ITEM 6. DEVELOPMENT APPLICATION: 161-165 CLARENCE STREET AND 304 KENT STREET SYDNEY**FILE NO: D/2012/1425****DEVELOPMENT APPLICATION NO: D/2012/1425****SUMMARY****Date of Submission:** 14 September 2012 (additional information received 2 November 2012)**Applicant:** Crown Central Developments Pty Ltd**Owner:** Crown Central Pty Ltd and Sathio Investments Pty Ltd**Architect:** Grimshaw**Developer:** Crown Central Developments Pty Ltd

Proposal Summary: The proposal is a Stage 1 Development Application for a new 80m tower envelope comprising residential, serviced apartments, retail and commercial development, including basement car parking. The proposal includes a new publicly accessible pedestrian space (centrally located between the podium blocks), through site link (connecting Clarence Street and Kent Street) and a laneway connection to Skittle Lane to the south. The application also seeks consent for a 10% uplift in FSR on the basis of a future competitive design process, and seeks to 'lock in' a residential car parking rate.

Summary Recommendation:

That a 'deferred commencement' consent be issued for D/2012/1425.

Figure 24 - typical upper level floor plan

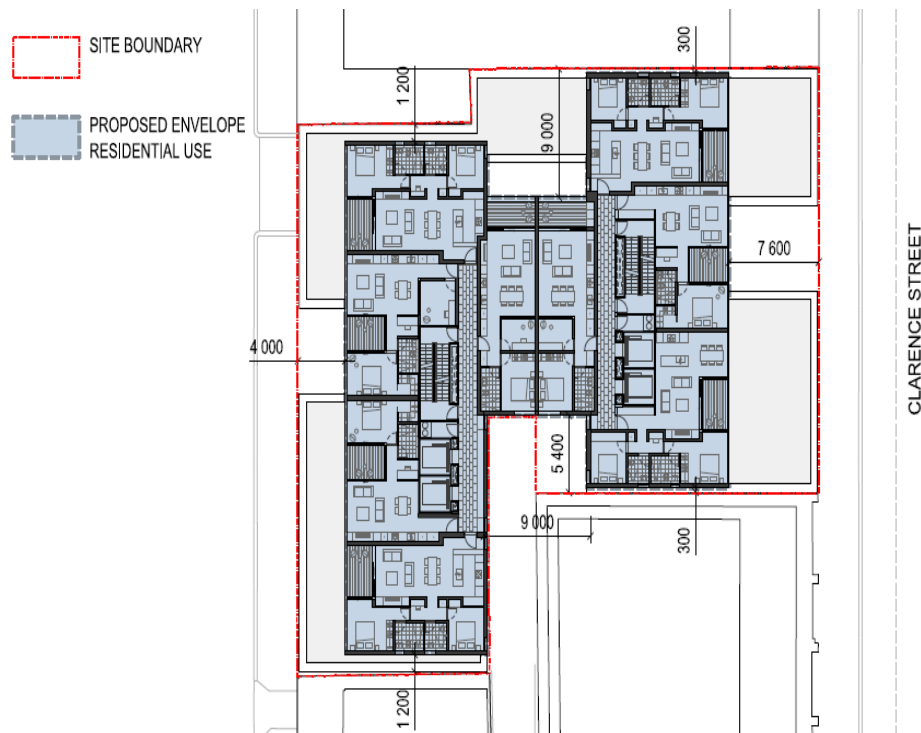
48. The following image outlines the varied setbacks proposed for the tower.

49. Central Sydney DCP 1996 requires a weighted average tower setback of 8m from the street wall, with a minimum setback of 6m.
50. The applicant intends to align the Clarence Street setback with the approved setback for the Red Cross House addition. This 'intention', however, is not reflected in the submitted drawings – proposed 7.6m setback; approved Red Cross House setback of 8m. A condition is recommended to increase the Clarence Street setback such that it does not protrude forward of the Red Cross House addition.

51. The 4m Kent Street setback does not comply with the DCP. The applicant, in responding to the requirement to provide an 8m setback for that part of the tower above the Red Cross House addition, submits that:

Above the street frontage height, the building is to be setback at least 8m from Clarence Street so as not to protrude forward of the approved addition to 153-159 Clarence Street, Sydney (Red Cross House).

Figure 30 - Ground level publicly accessible pedestrian space (centrally located between the podium blocks) and laneways

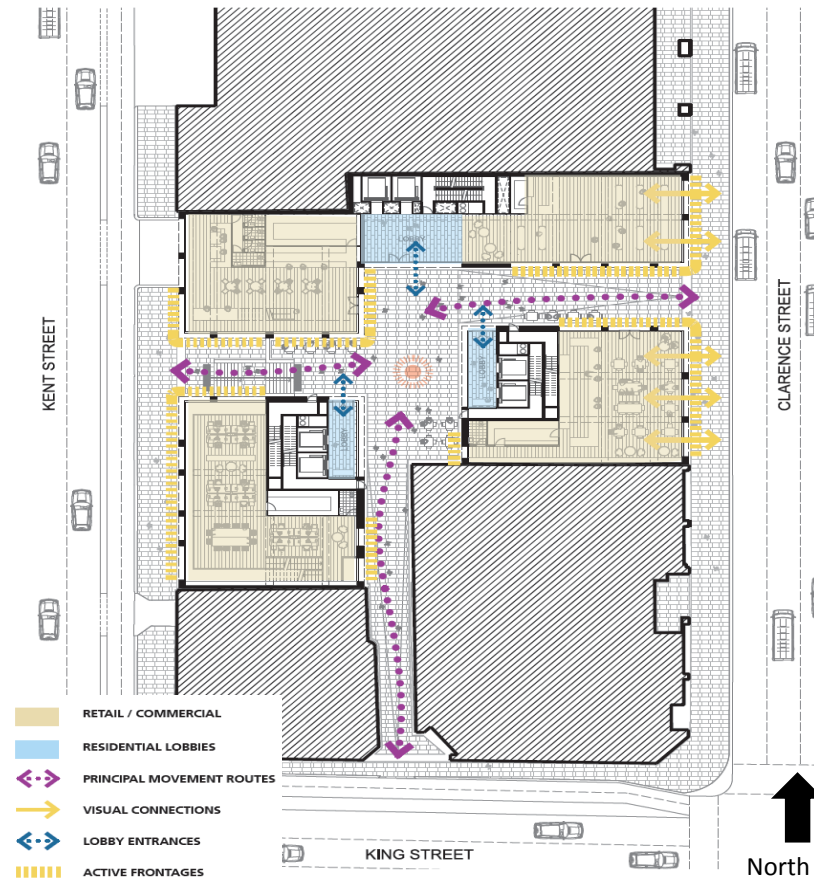
- (c) requires retention and improvement of Skittle Lane.
59. The proposal includes a new publicly accessible pedestrian space (centrally located between the podium blocks) and pedestrian links connecting Clarence Street, Kent Street and Skittle Lane. The publicly accessible space and pedestrian connections will be defined by vertical voids, part open to the sky, part enclosed, and activated by retail uses and residential entries. This arrangement, particularly the opportunity to revitalise Skittle Lane, has merit and is supported.

60. As part of the future competitive design process and detailed Stage 2 DA, the pedestrian links will need to carefully consider the significant level change between Clarence and Kent Streets, and should explore the merit of providing a visual connection between the two streets. Detailed design and view analysis should be submitted as part of the future application.

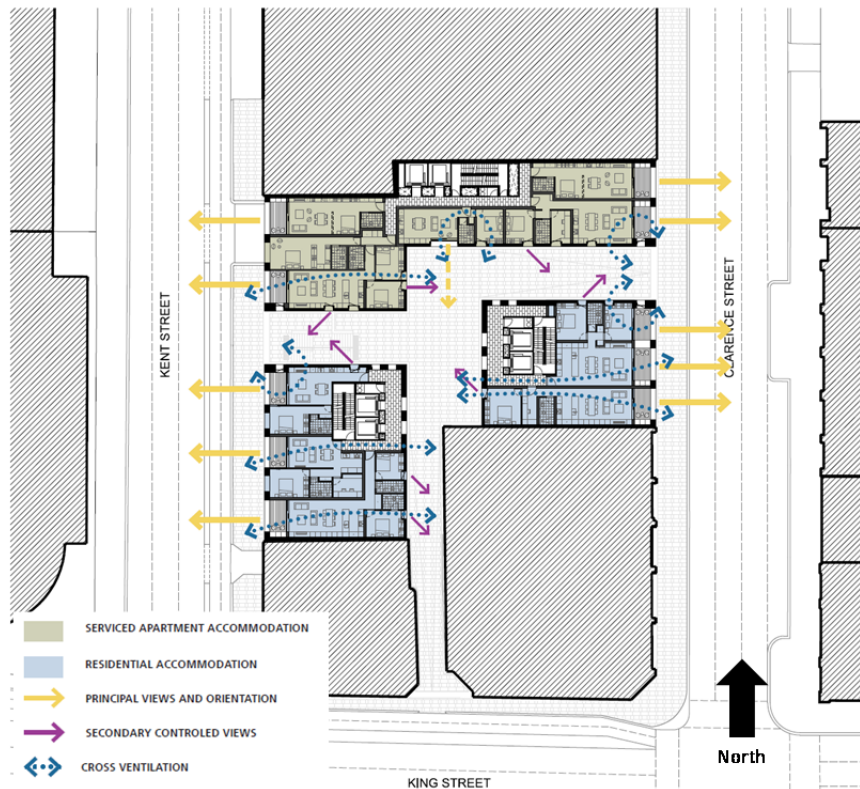
61. The provision of the publicly accessible space and pedestrian links, activated by retail uses, will need to be carefully balanced with the amenity of the apartments within the podium blocks, particularly in terms of both acoustic attenuation and ability to provide meaningful cross ventilation.

62. Accordingly, while the Stage 2 DA design of the laneways, publicly accessible space and apartments will be the subject of a competitive design process and detailed wind and acoustic analysis, the general intent of the concept has merit and is supported. It is nevertheless prudent to include a condition of consent to outline the Council's expectations for the future application, and the need to carefully balance residential amenity and the quality of the publicly accessible space and laneway space.
63. It is noted that the northern podium block is proposed for short stay service apartment use.

Figure 36 – Mid-winter shadows at 3pm

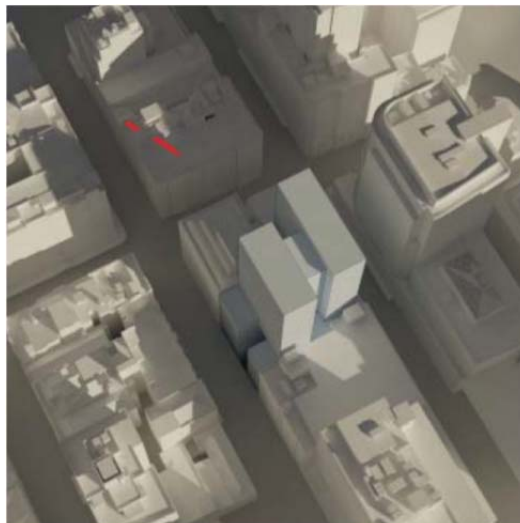
65. The proposal will result in additional overshadowing of Broughton House. This impact, however, is considered to be reasonable, particularly noting the following:
- (a) The proposed building envelope is LEP and DCP compliant (with the exception of the 4m tower setback from Kent Street) with the shadow casted largely the result of a compliant development;
 - (b) As discussed earlier, the proposed 4m tower setback from Kent Street is acceptable;
 - (c) In mid-winter (21 June), the additional shadow cast (from a 4m Kent Street setback as opposed to an 8m setback) only lands on the upper facade and rooftop of Broughton House from around 1pm onwards, as illustrated on the following images:

- (e) Under the LEP, Broughton House is vulnerable to overshadowing as the neighbouring north and north west street blocks both have high densities and a 80m height limit;
- (f) In the context of inner city living, the expectation of protecting sunlight access is not strong.

Figure 39 – Mid-winter shadows at 1.30pm

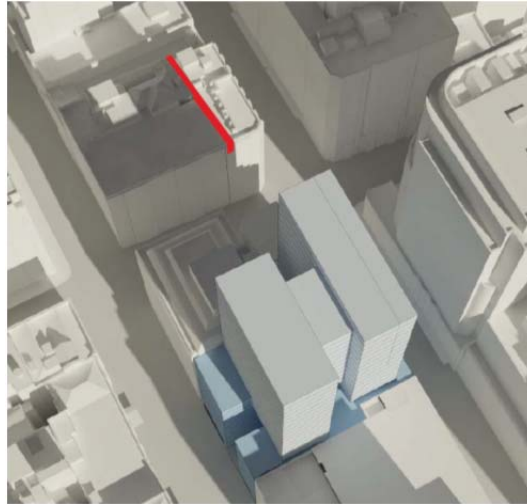
- (d) More precisely, the additional mid-winter impact is some 15 minute in duration as illustrated in the following images:
